PLAN VIEW THOMAS JEFFERSON MEMORIAL NATIONAL MALL AND MEMORIAL PARKS

128232 SHEET 6 of 54

SEAWALL REINFORCING
DETAILS AT CAISSON
(NO PIPE PILES)
THOMAS JEFFERSON MEMORIAL
NATIONAL MALL AND MEMORIAL PARKS

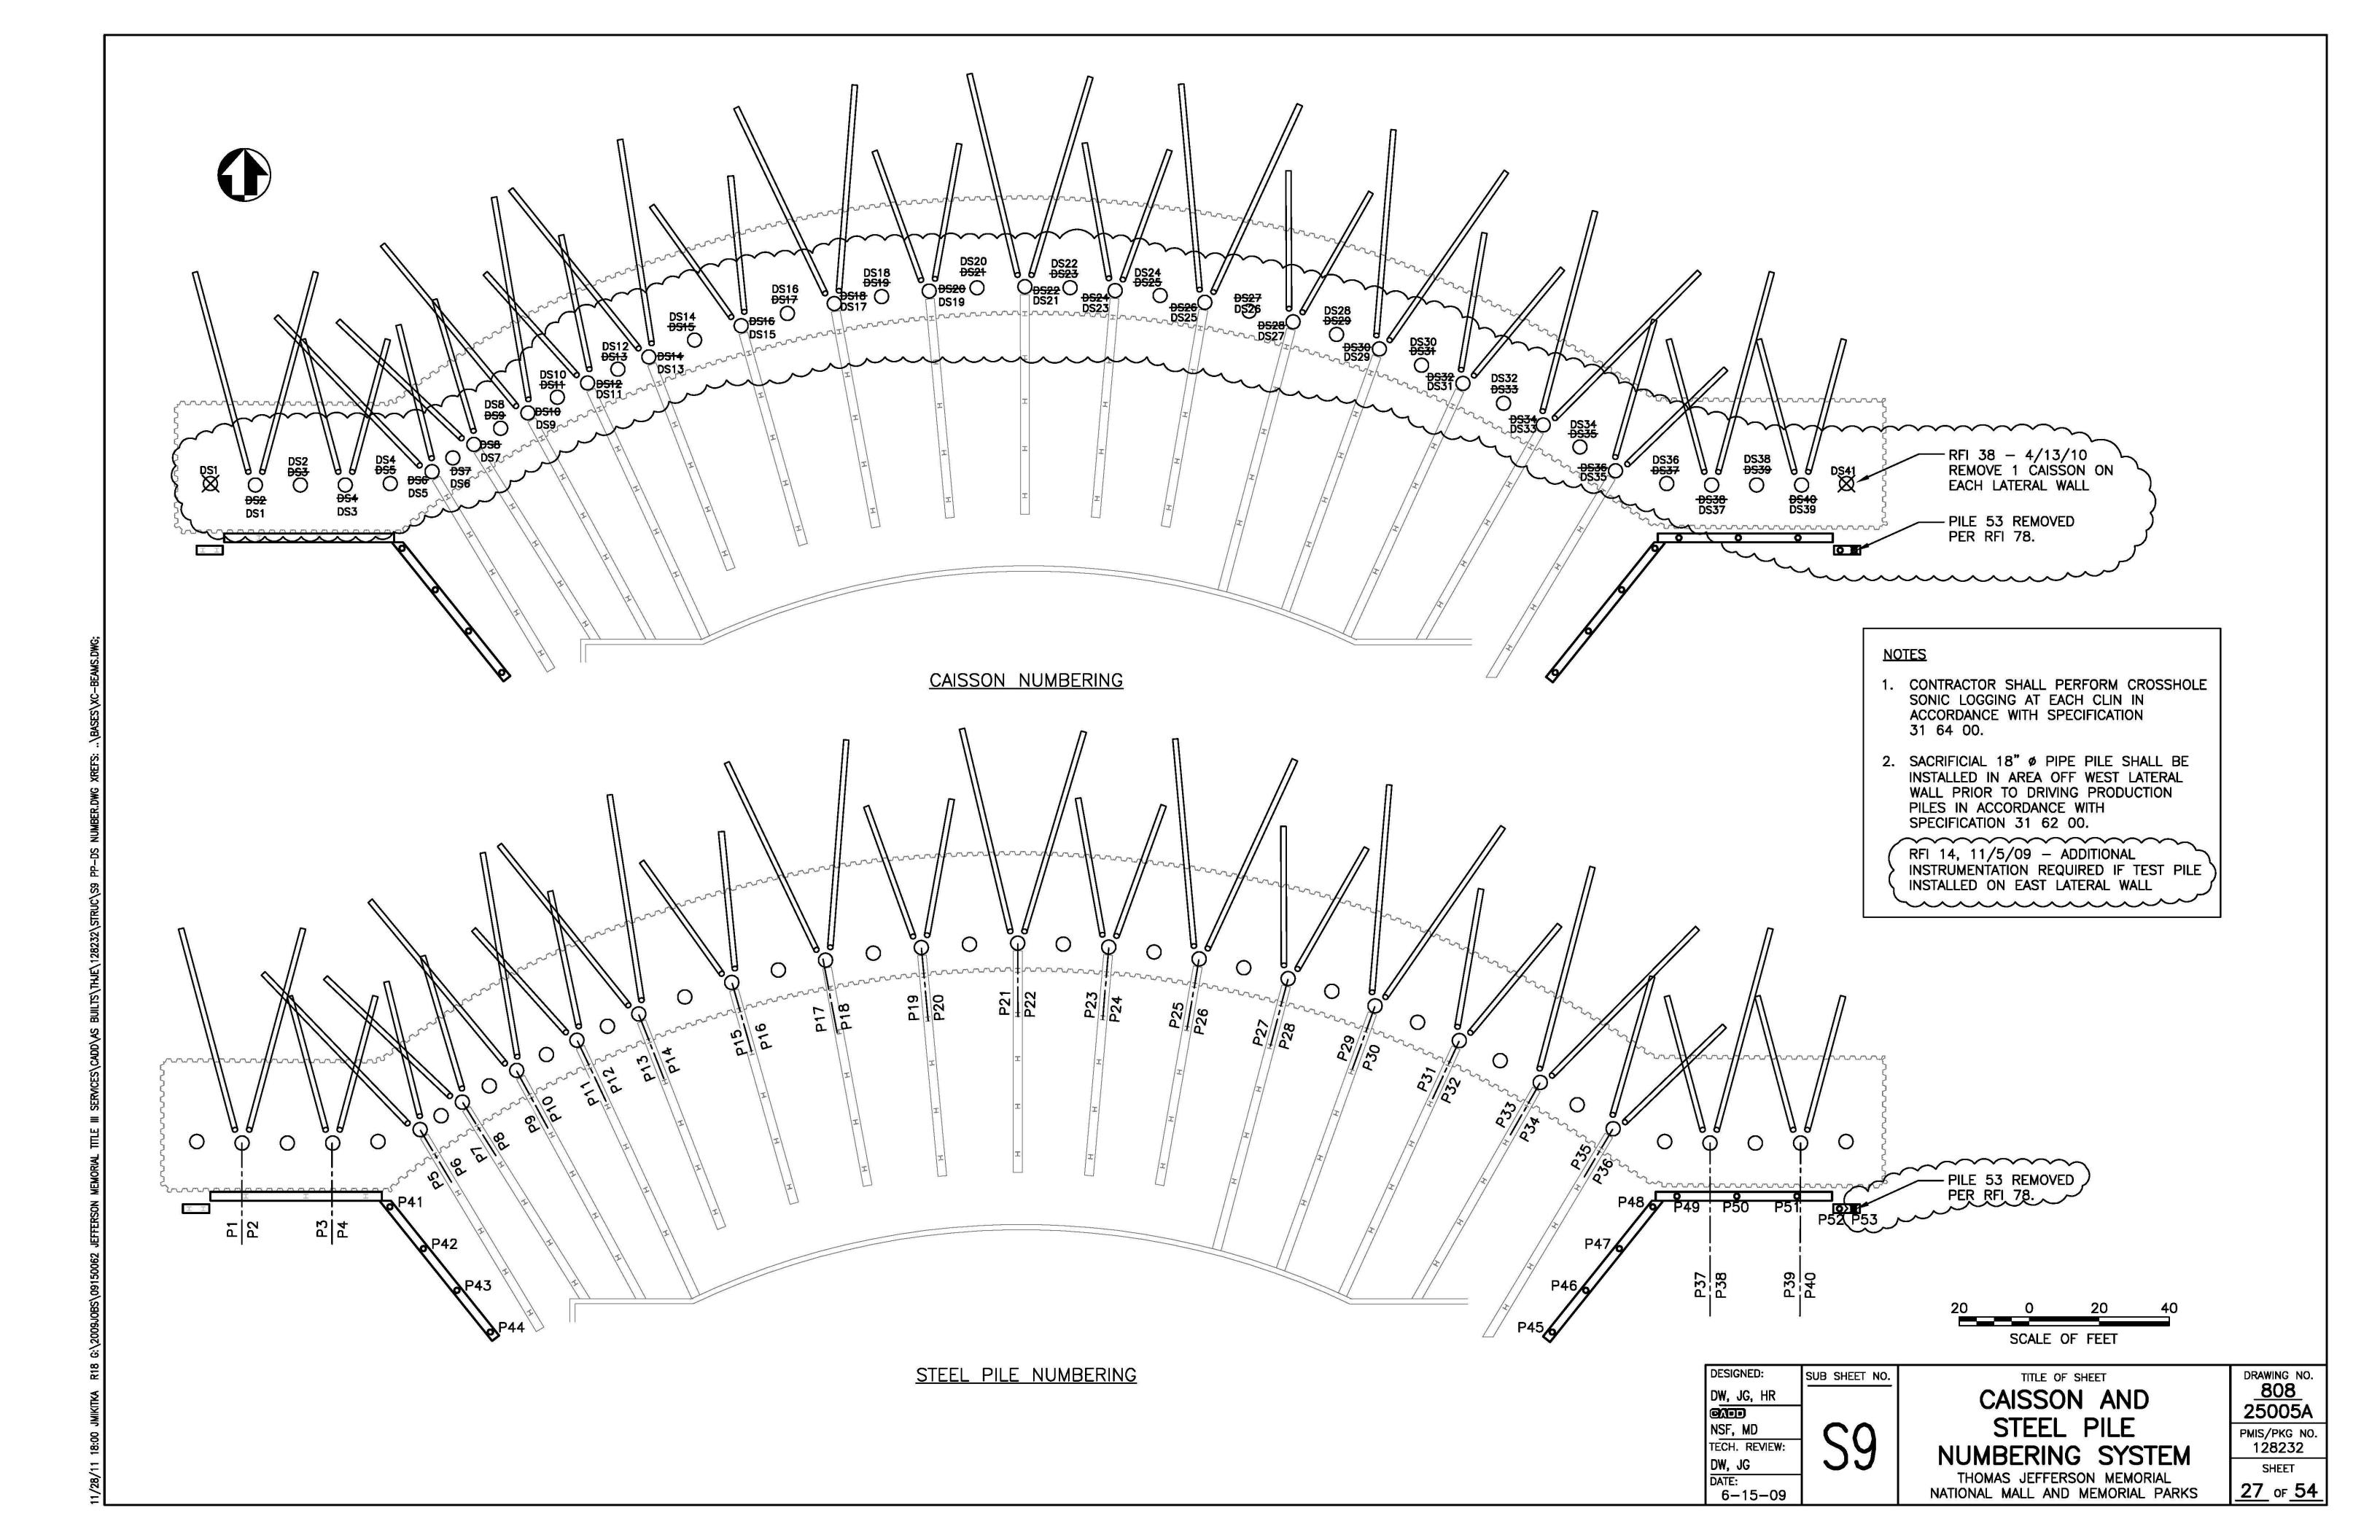
RFI 0115, 1/15/11
REBAR/FACING STONE CONFLICT AT 77B
(RADIAL TO LATERAL CONNECTION ON
WEST SIDE OF SEAWALL). REBAR TO BE
MODIFIED AS SHOWN IN RFI RESPONSE.

CAISSON DETAILS

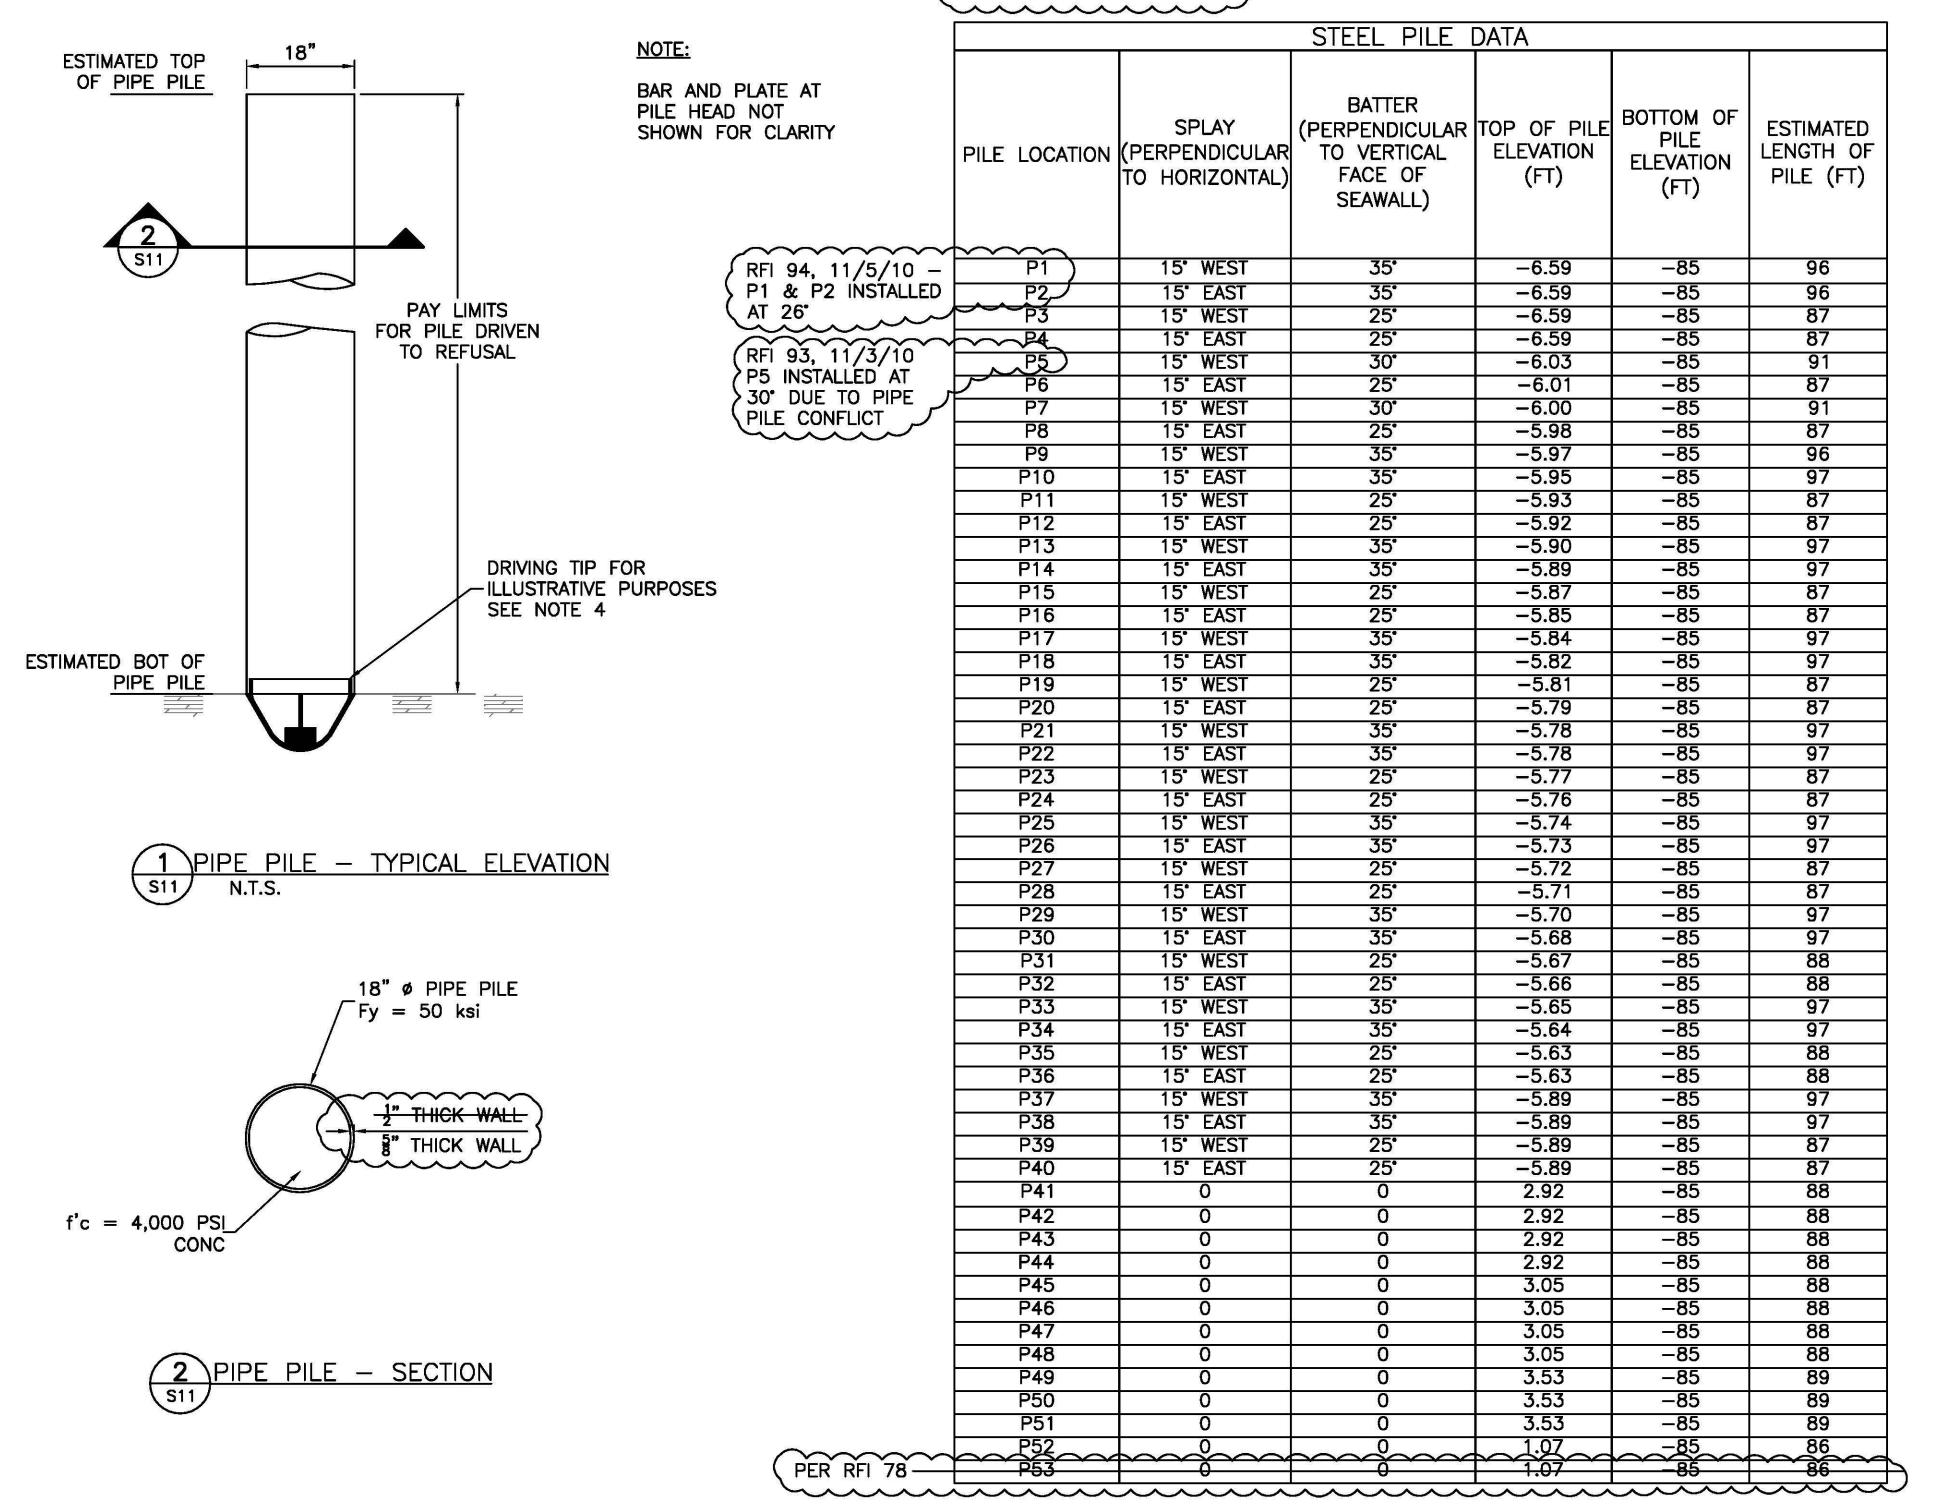
1. THE METHOD OF ADVANCING THE HOLE SHALL BE APPROVED BY THE CONTRACTING OFFICER PRIOR TO CAISSON CONSTRUCTION. 2. CONTRACTOR SHALL NOT YIELD OR PERMANENTLY DEFORM REBAR CAGES DURING LIFTING, HANDLING OR PLACEMENT. RFI 21, 12/01/09 SPLICES SHALL BE MADE USING APPROVED RFI 31, 2/26/10 MECHANICAL CONNECTORS IN ACCORDANCE WITH MINIMUM STAGGERED AASHTO DIV. 1, SEC. 8.32 NO LAP SPLICES OR 4- CROSSHOLE WELDED SPLICES WILL BE PERMITTED. STAGGER CLEAR DISTANCE OF 2 FT SONIC LOGGING TUBES, 2" REINFORCEMENT SPLICES A MINIMUM OF 3'. I.D. SCH. 40 STEEL PIPES SEE NOTE 8 SPLICES ON VERTICAL REINFORCEMENT SHALL NOT BE #4 TIES @ 18-24" OC (SEE DET 1) PLACED WITHIN 10 FT OF THE ROCK SOCKET OR IN THE TOP 30 FT OF THE SHAFT. 24 #14 BARS, APPROVED SPACERS SHALL BE USED TO ALIGN GRADE 60 STEEL REINFORCEMENT WITHIN THE CAISSONS. 6. CONCRETE USED IN CAISSONS SHALL HAVE A MINIMUM 28-DAY COMPRESSIVE STRENGTH OF 4000 3" CL. 7. VERTICAL BARS TO BE CONTINUOUS WITHIN CAISSON TO SEAWALL CONNECTION. f'c = 4,000 PSICONC RFI 24, 12/10/09 CROSSHOLE SONIC LOGGING TUBES SHALL BE CSL TUPES IN CAISSONS: INSTALLED DURING THE CONSTRUCTION OF TWO DS3 **DS29** CAISSONS IN THE FIRST CLIN AND ONE CAISSON AT DS13 DS33 DS39 EACH ADDITIONAL CLIN LOCATION. SEE SPECIFICATION DS21 31 64 00. RFI 49, 7/14/10 REVISED CSL TUBE CAISSON CONCRETE MUST BE COMPLETED A MINIMUM CAISSON SECTION VIEW - (TYP) OF 14 DAYS PRIOR TO CONSTRUCTION OF SEAWALL. LOCATIONS 10. REFER TO SHEET G1 GENERAL NOTES. RFI 48, 6/11/10 PROPOSED CAISSON TIP ELEVATIONS

STEEL PILE DETAILS AND SCHEDULE

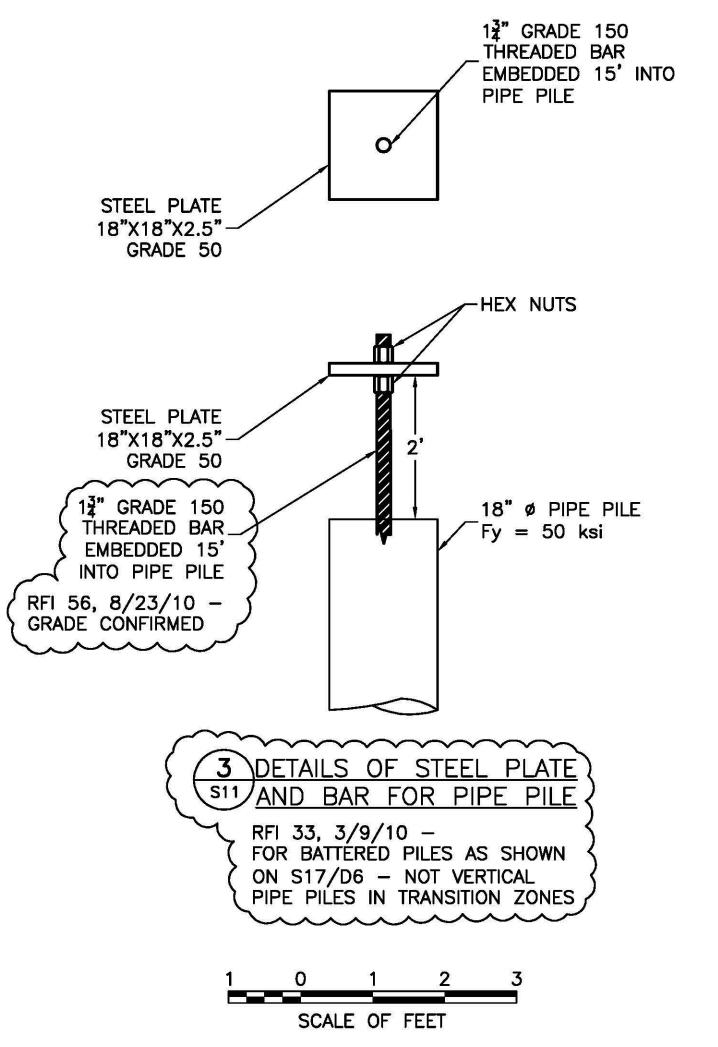
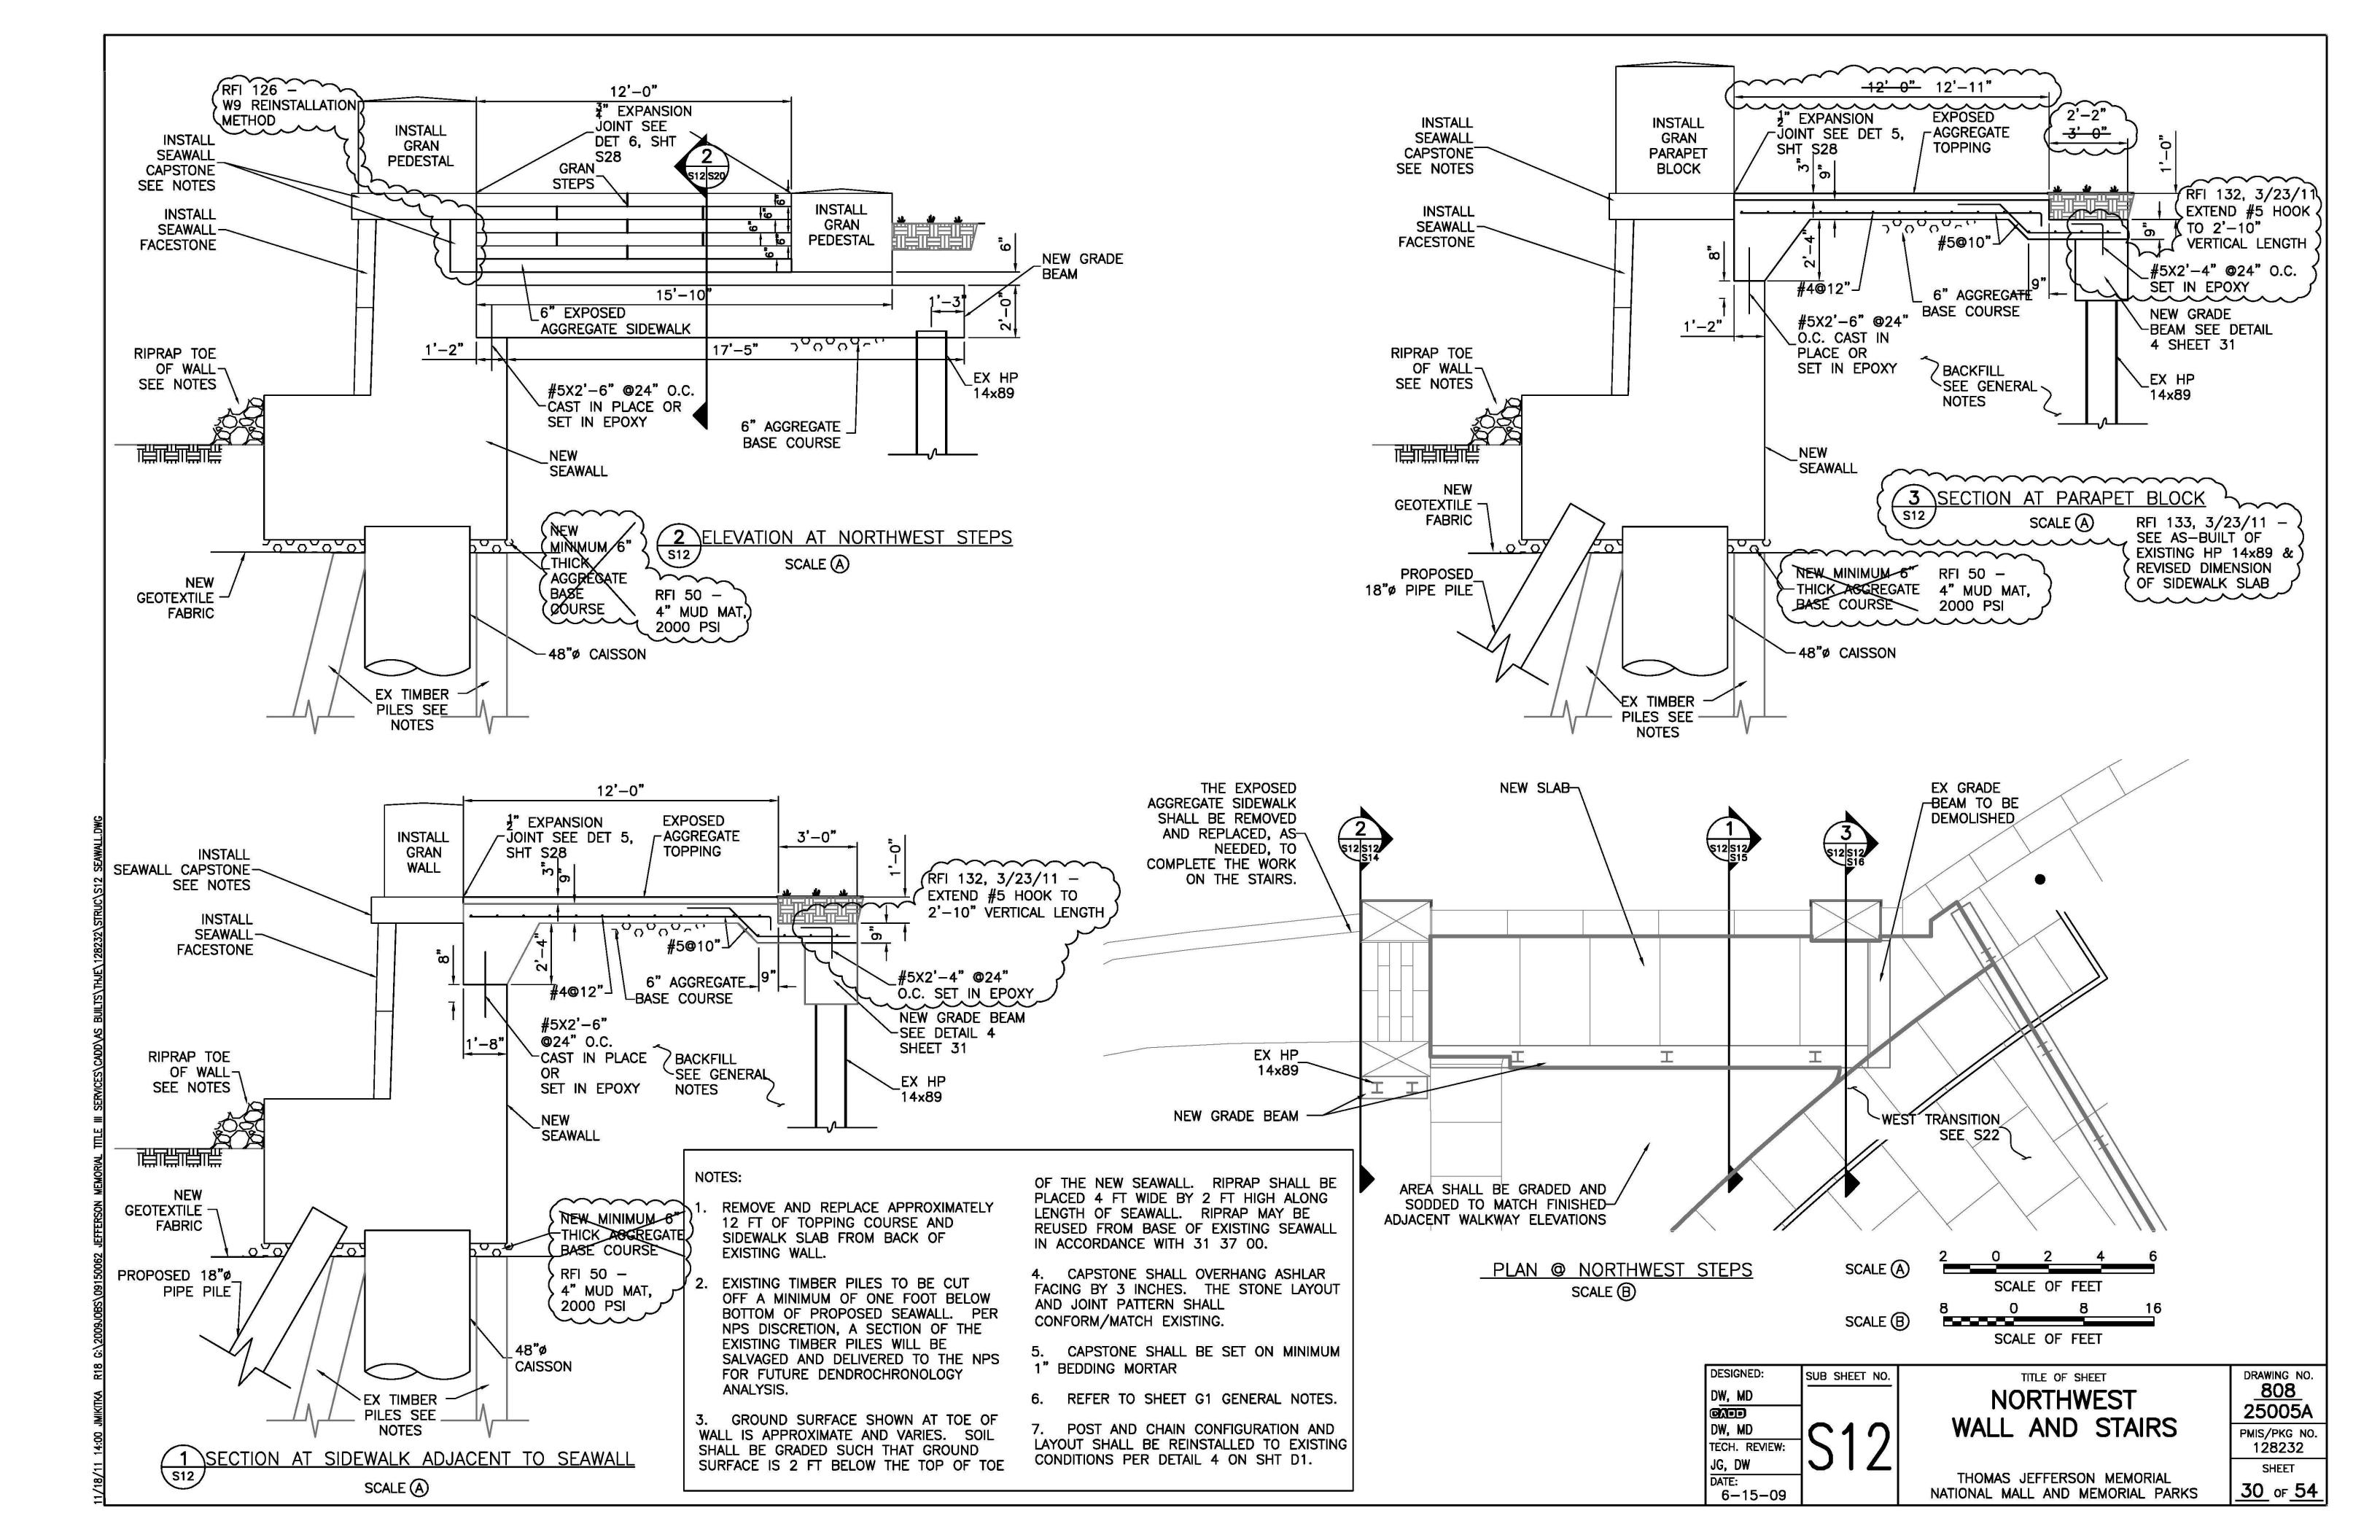
~~~~~~ RFI 0026, 1/20/10 -P4, P5, P7 LOCATION AND DEGREE OF BATTER MODIFIED
